**INVITATION TO BID
ANC 23-26C
Anchorage Pioneer Home 3rd Floor Resident Renovations**

ADDENDUM NO. 3

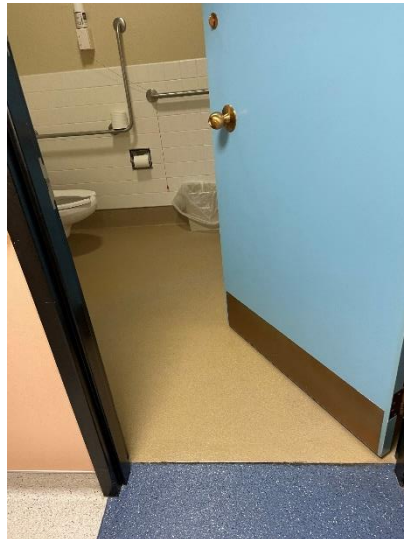
Question 1. The floor drains will require patching the floor tile.

Response: Toilet Rooms 323.1 and 337.1 have sheet vinyl floors and the drains will work well with the existing flooring. Please leave the existing sheet vinyl and floor drains as existing.
